<b>Name</b>	<b>Job Title</b>	<b>Signature</b>	<b>Date</b>
<b>Application made by:</b>	SCS	<b>Section engineer Environmental Advisor</b>		10/12/2019
<b>Location (Sector/Site Name) and address:</b>	Park Village East (PVE), Euston Scissor Box, Euston Approaches, HS2			
<b>Nearest postcode / Grid references</b>	NW1 7SN			
<b>LAA/LAP/Site Reference</b>				
<b>Date of Tree Panel:</b>	01/01/2020	<b>Meeting No:</b>	24

**Site Description:****Park Village East Wall and Planter**

Figure 1: Image of the PVE Planter North of Mornington Crescent bridge

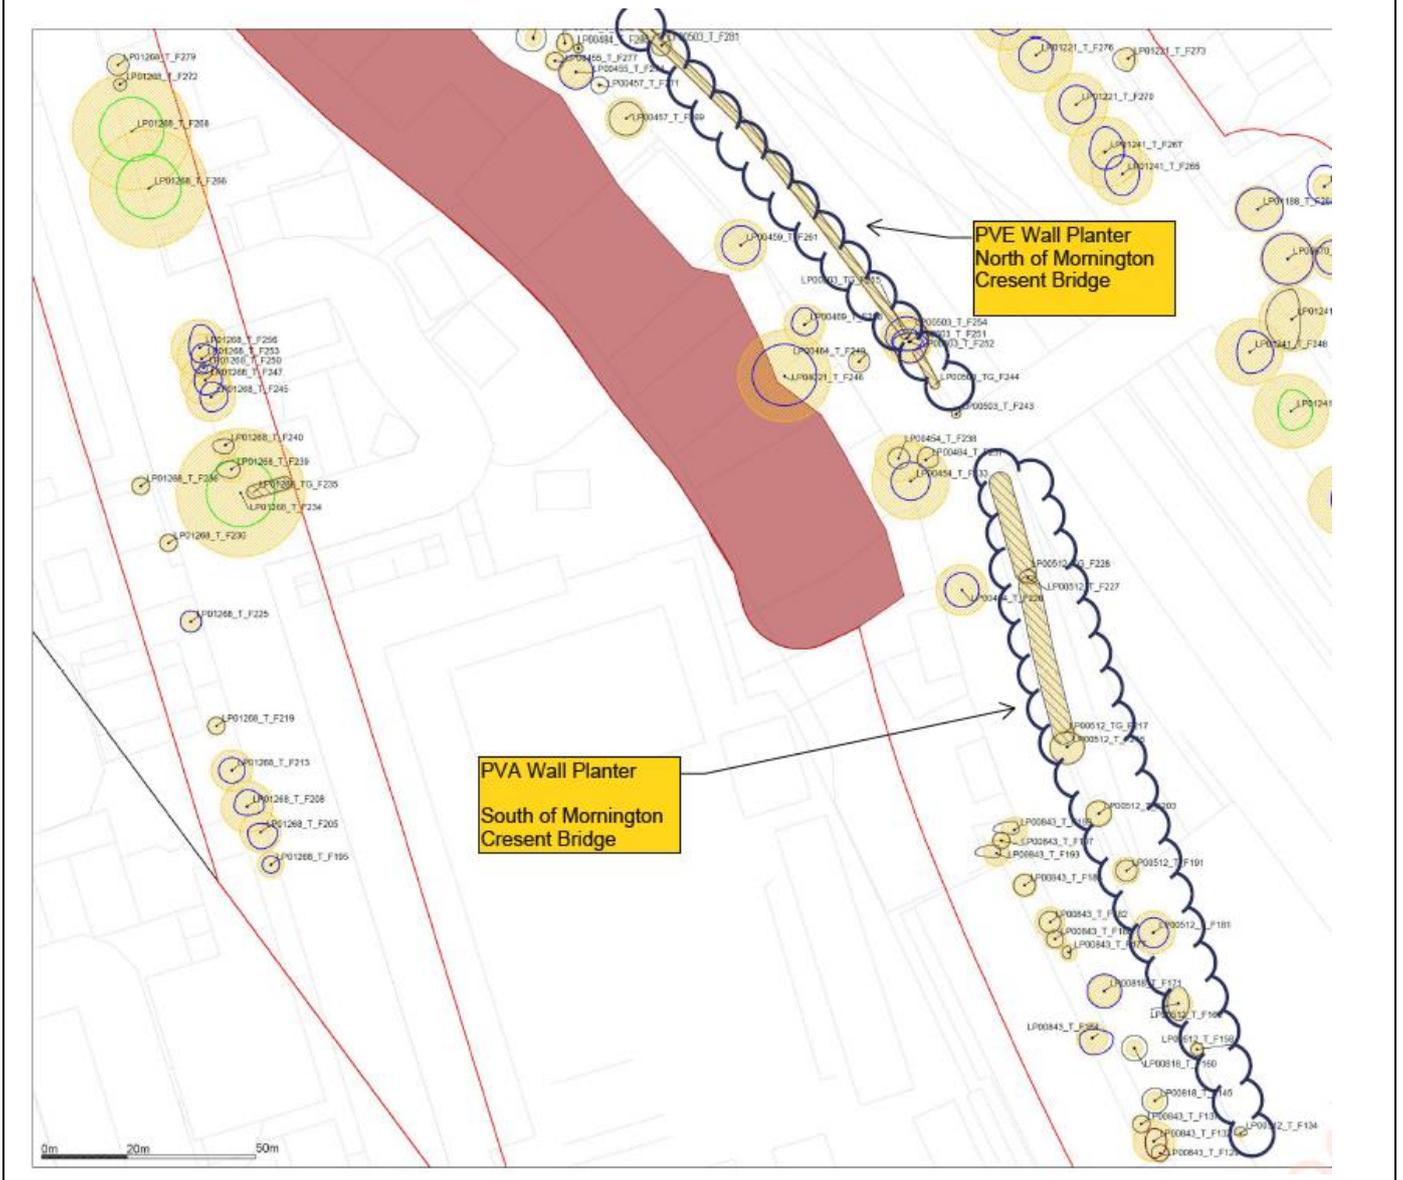
<p><b>Proposal Endorsed/Not Endorsed:</b></p>	<p><b>Not endorsed</b></p>
<p><b>Conditions</b></p>	<p><b>Tree removal not endorsed, however, tree pruning where required to survey the wall is endorsed. Expectation that shrub removal will also be carried out without excavation.</b></p>
